BROWNS FERRY NUCLEAR PLANT (BFN) - RESPONSE TO REQUEST FOR ADDITIONAL INFORMATION (RAI) RELATING TO UNITS 2 AND 3 TECHNICAL SPECIFICATION (TS) CHANGE NO. TS-384 - POWER UPRATE OPERATION (TAC NOS. M99711 AND M99712)

ENCLOSURE
TENNESSEE VALLEY AUTHORITY
BROWNS FERRY NUCLEAR PLANT
UNITS 2 AND 3

BROWNS FERRY NUCLEAR PLANT (BFN) - RESPONSE TO REQUEST FOR
ADDITIONAL INFORMATION (RAI) RELATING TO UNITS 2 AND 3 TECHNICAL
SPECIFICATION (TS) CHANGE NO. TS-384 - POWER UPRATE OPERATION
(TAC NOS. M99711 AND M99712)

Figure 1-1: FSAR Benchmark Case - Suppression Pool Temperature Response at Pre-Uprate Power

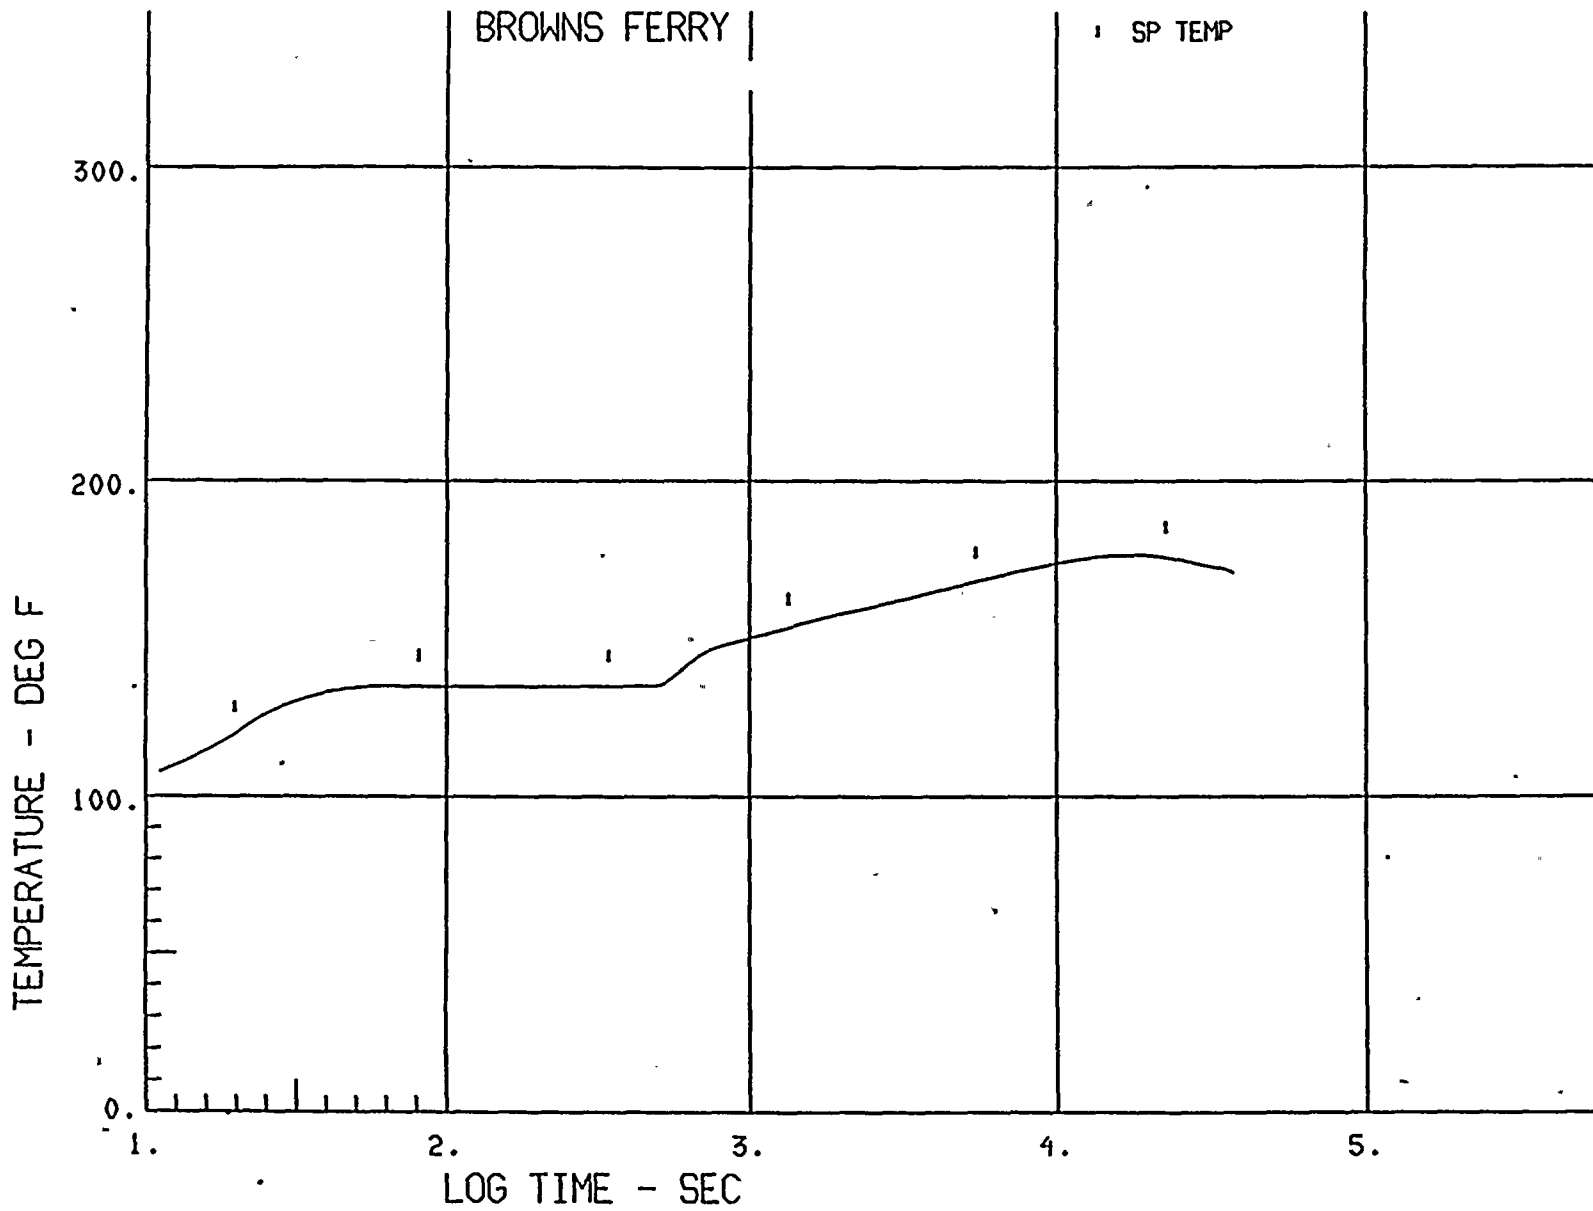
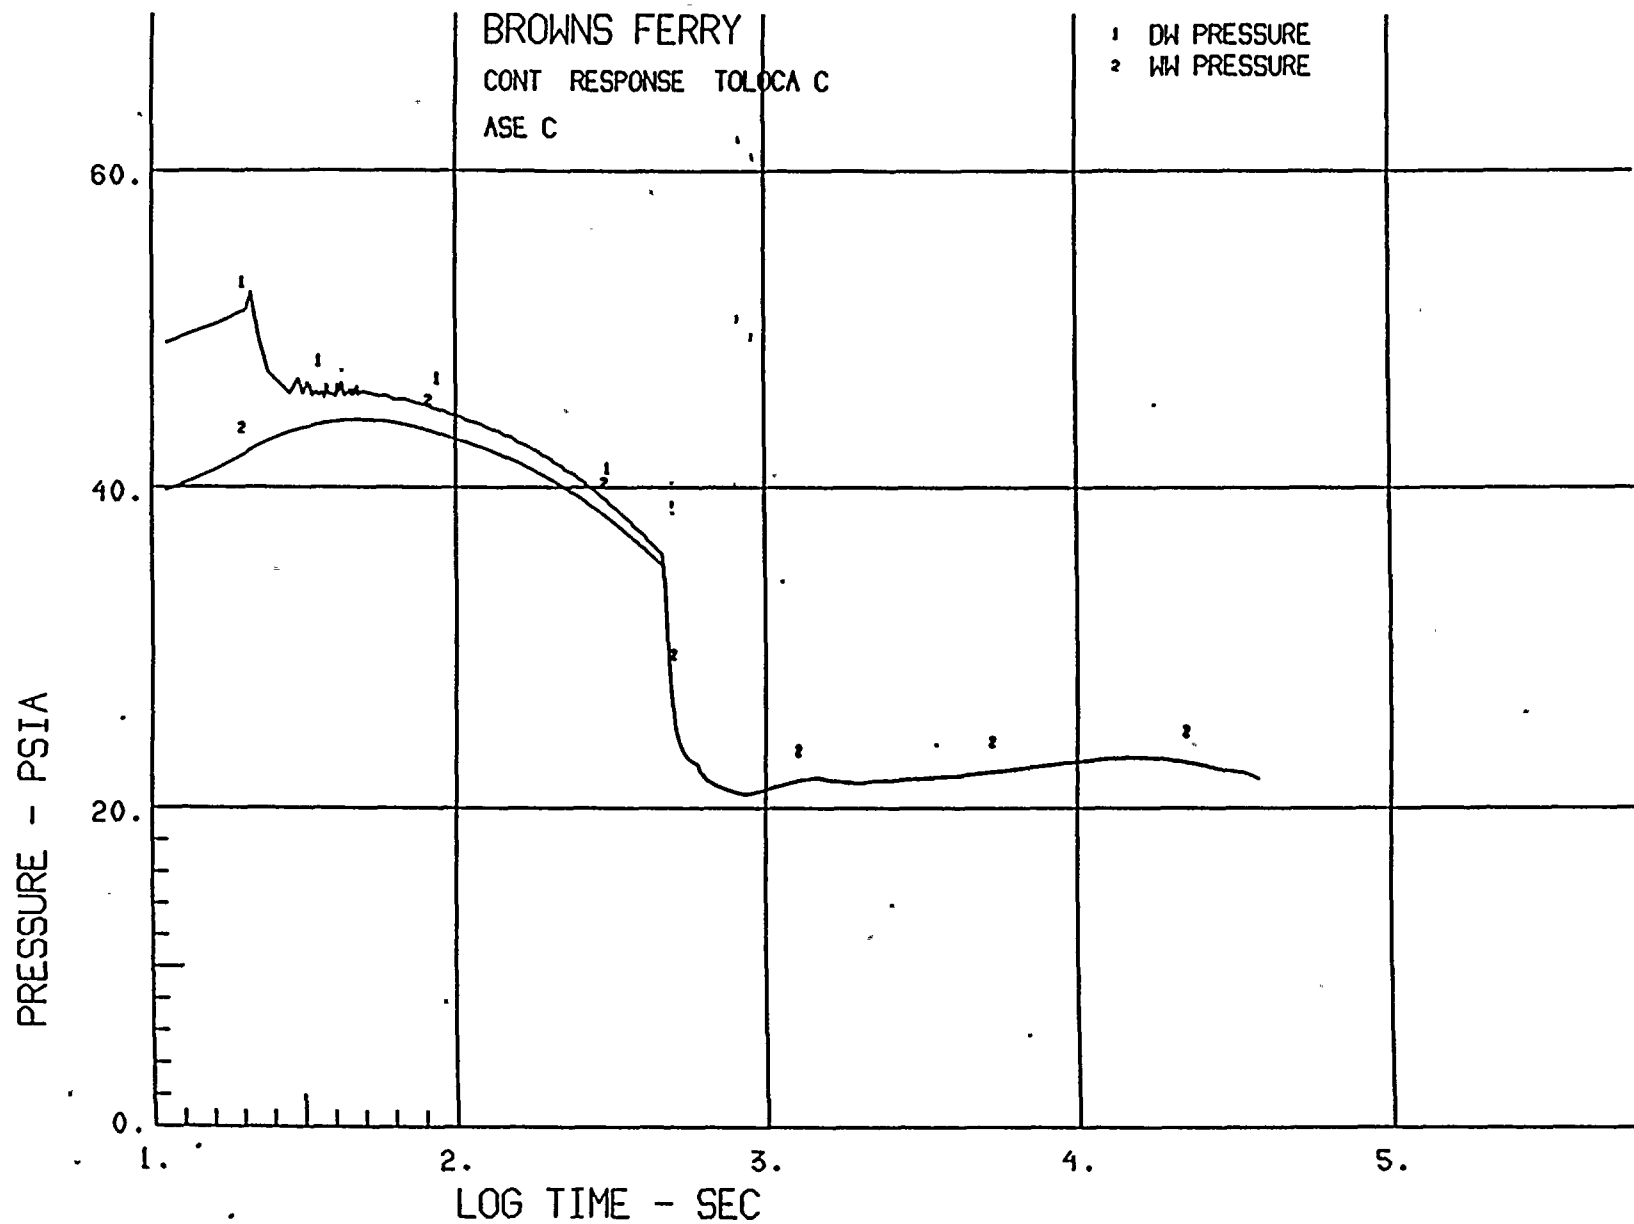
In Section 4.1.1.1, Containment long term pool temperature response, it is indicated that a pre-uprate SHEX code benchmark evaluation was performed using a heat exchanger K-factor of 223 BTU/sec-°F, 92° F Residual heat removal (RHR) service water (SW) temperature, 6500 gpm RHR flow rate, and 4000 gpm RHR SW flow rate. The analysis resulted in a peak suppression pool temperature of 1750° F [sic]. These values are not consistent with the existing BFN analysis which used a heat exchanger K-factor of 228 BTU/sec-°F, 95° F RHR service water temperature, 6500 gpm RHR flow rate, and 4500 gpm RHR SW flow rate and reported a peak pool temperature of 1770° F [sic]. The existing analysis was performed using the May-Witt decay heat curve while the uprate was performed using the ANS/ANSI 5.1 (2σ uncertainty). The comparative analysis should use the same input assumptions. Please justify this inconsistency discrepancy. Also, please provide the containment temperature and pressure profiles.

A plant-specific SHEX benchmark case using inputs consistent with the Updated Final Safety Analysis Report (UFSAR) basis (i.e., heat exchanger K-factor of 228 BTU/sec-°F, RHR service water temperature of 95° F, 6500 gpm RHR flow rate, 4500 gpm RHR SW flow rate and May-Witt decay heat curve) was performed for BFN as part of the power uprate containment analyses. The resulting maximum suppression pool temperature is 176.7° F. This result is in agreement with the UFSAR analysis which was prepared using the licensing basis computer code. Thus, it is concluded that the change in computer codes does not affect the results. As requested by this question, the suppression pool temperature and drywell and wetwell vapor space pressure profiles for this benchmark case are attached as Figures 1-1 and 1-2.

Figure 2-1: DBA-LOCA Containment Temperature Response at Power Uprate Condition

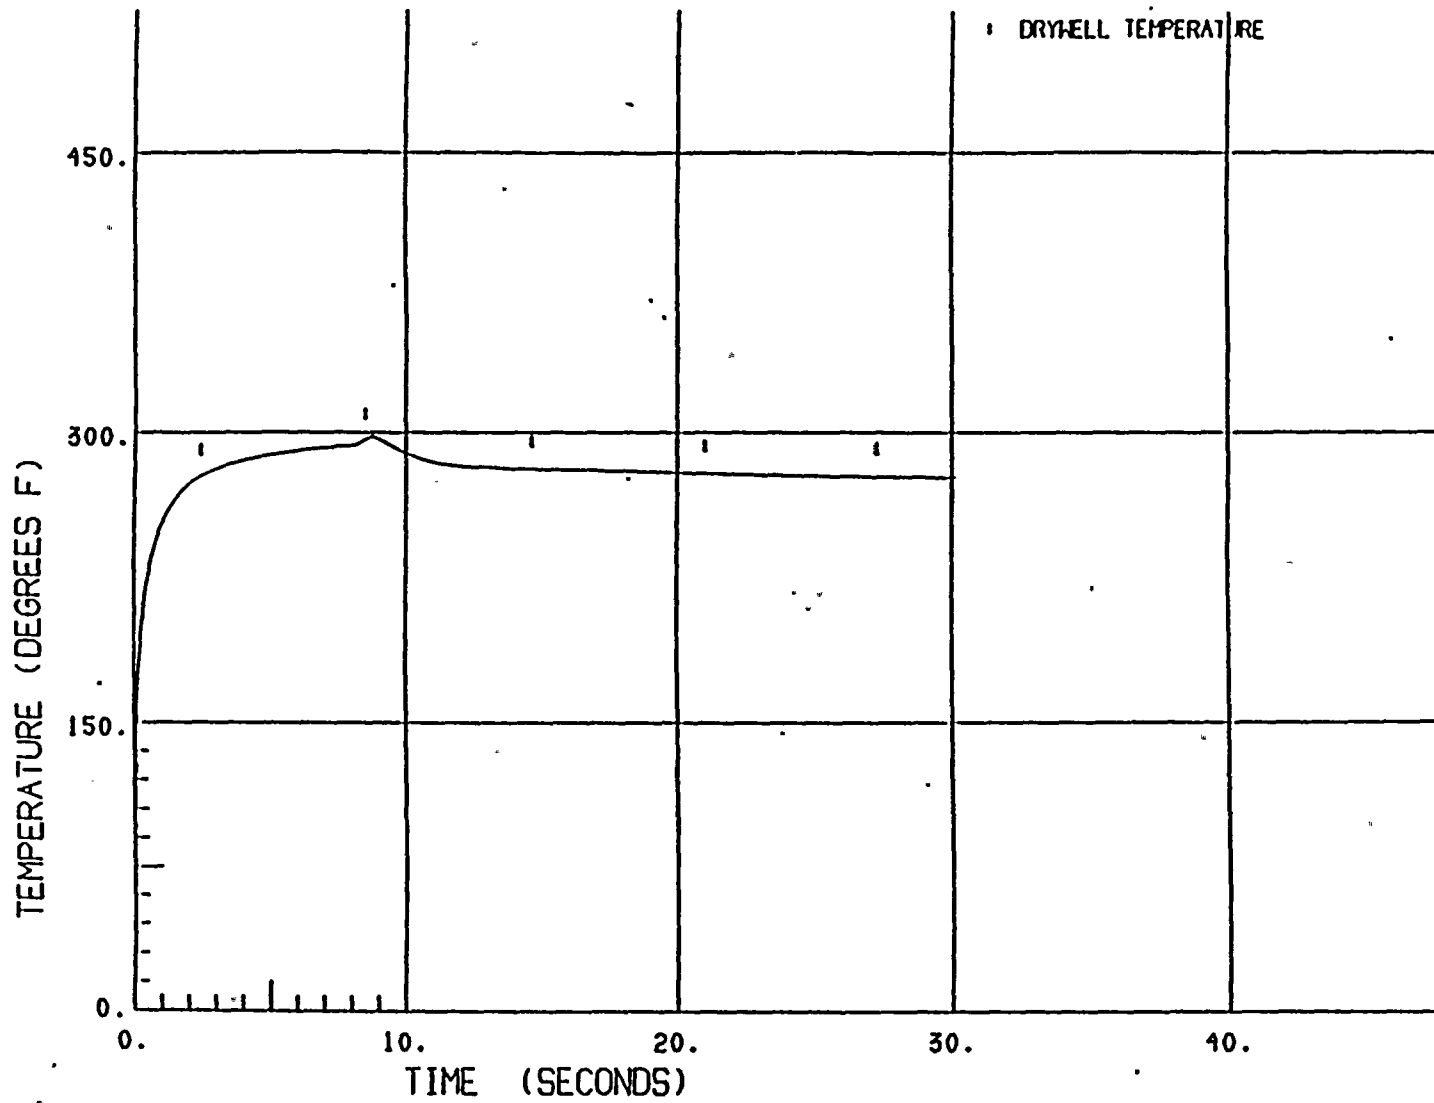
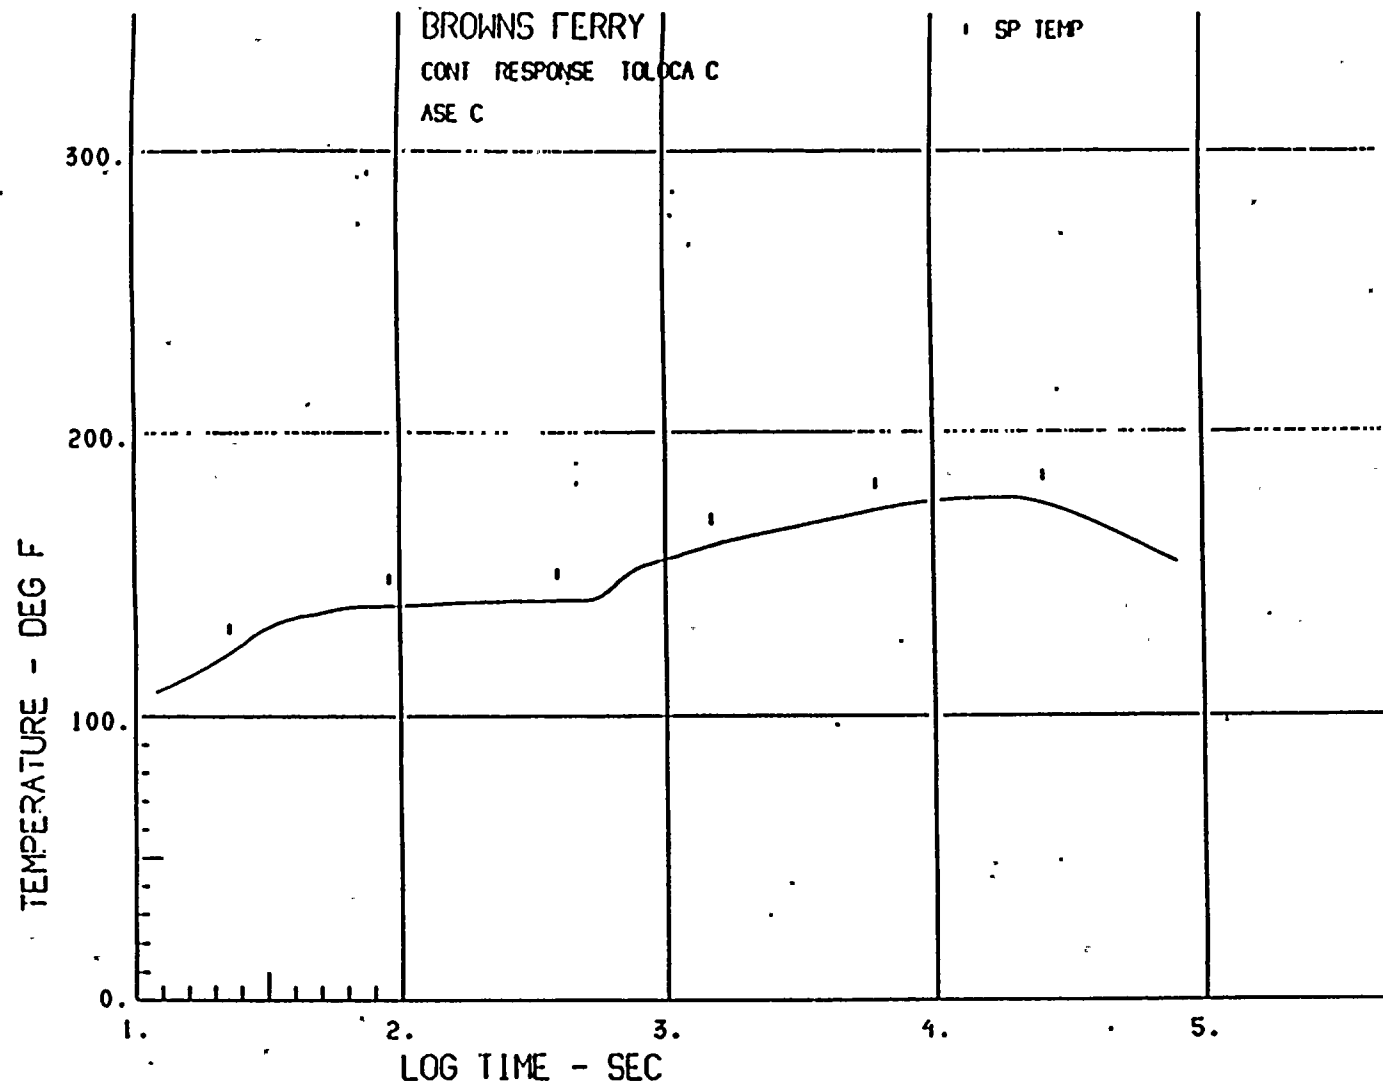
Section 4.1.1.2, Containment Gas Temperature Response indicates that at uprated power, the calculated peak drywell airspace temperature exceeds the drywell shell design temperature, but only at the beginning of the accident and for a short period of time. This is not considered a threat to the drywell shell structure due to relative long drywell shell heat-up time. Please provide the containment temperature profiles after a loss-of-coolant-accident.

The containment drywell and wetwell vapor space temperature profiles for Power Uprate conditions are provided in Figures 2-1 and 2-2.
